AppIn No. 10/736,751
Amendment dated November 2, 2005
Response to Office action of May 2, 2005

Amendments to the Drawings:

Remarks/Arguments:

FIG. 1

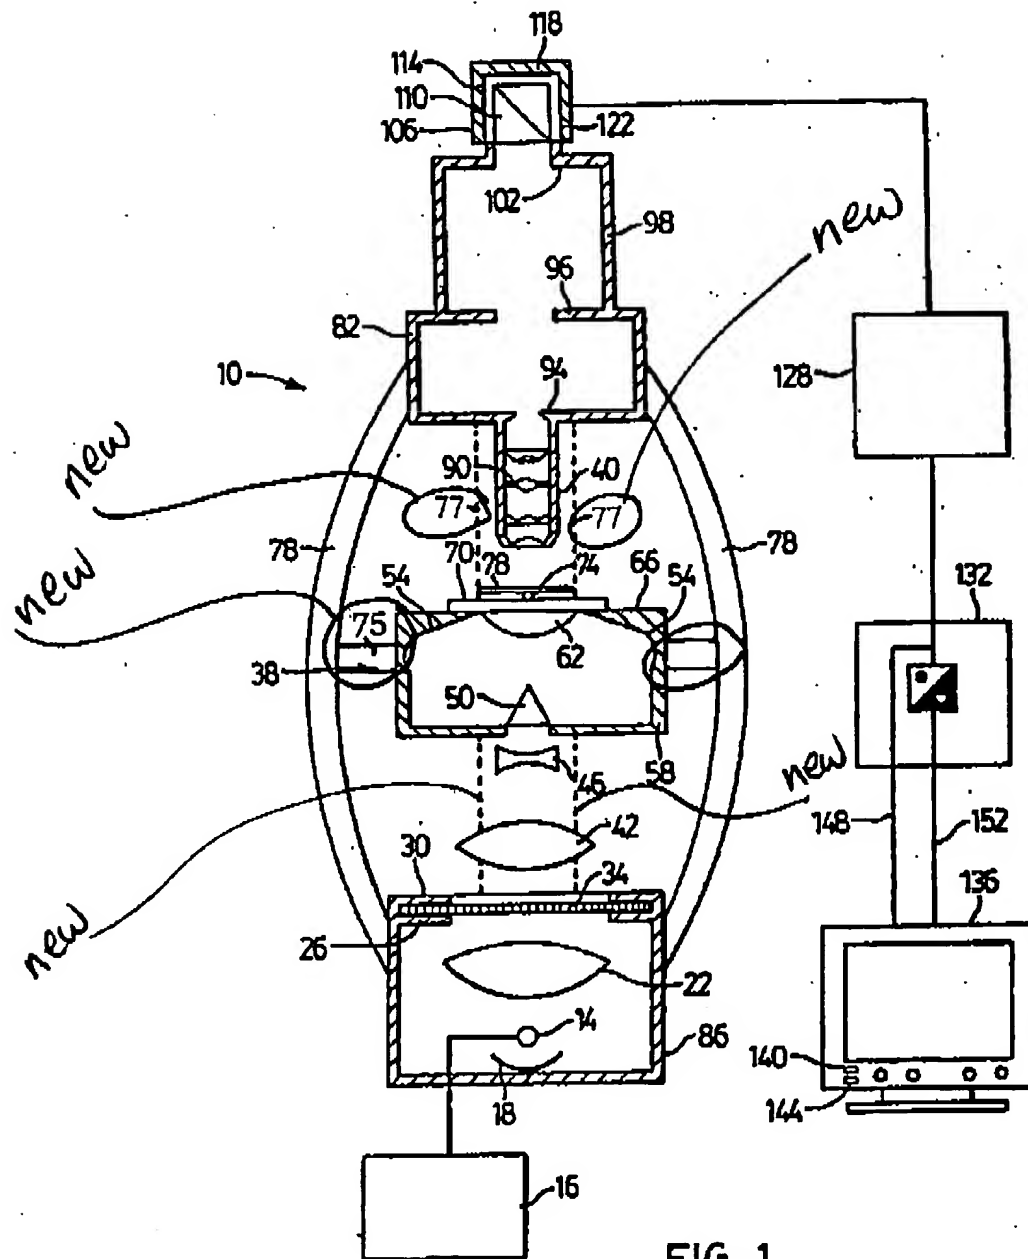
In Figure 1, elements 75 and 77 have been added.

The feature related to a C-shaped frame connecting the head portion and the base portion as recited in claims 1 and 18 has been added as element 77 in Figure 1.

The feature related to a hydraulic cylinder for coupling the braces together is now illustrated schematically as element 75 in Figure 1. Paragraph [00074] has been amended accordingly. Applicant respectfully submits that these amendments add no new matter as hydraulic cylinders are well known. A spelling error has also been corrected in paragraph [00074].

The feature related to a piezoelectric strut is now described in paragraph [00075] as being located similarly to cylinder 75 shown schematically in Figure 1. Applicant thus respectfully submits that no further amendment of the drawings in this regard is required. The feature related to a piezoelectric layer is now described in paragraph [00075] as being located as illustrated in Figure 3, in which figure the element was illustrated as filed. Paragraph [00076] has been amended to name the element as layer 204 for the sake of consistency. The fifth line of paragraph [00075] has been amended to replace the term "strut" with the term "brace". It would be evident to the reader that this was the intended term since the remainder of the sentence refers to lower and upper halves of the braces. A spelling error has also been corrected in paragraph [00075].

FIG. 4a

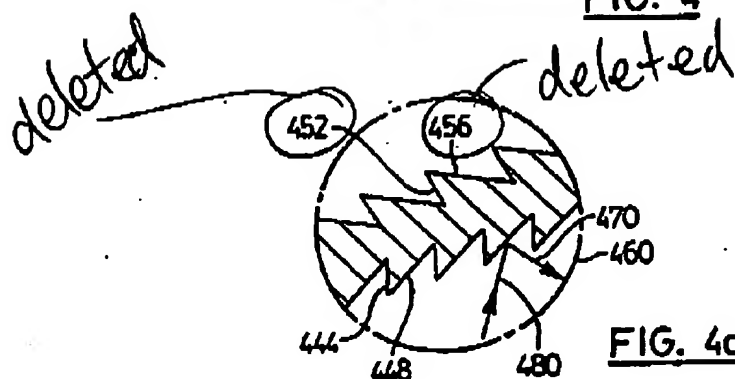
In Figure 4a, numerical references "452" and "456" have been deleted.

Numerical references "452" and "456" have been deleted from Figure 4a. Applicant believes this meets the objection to this figure.
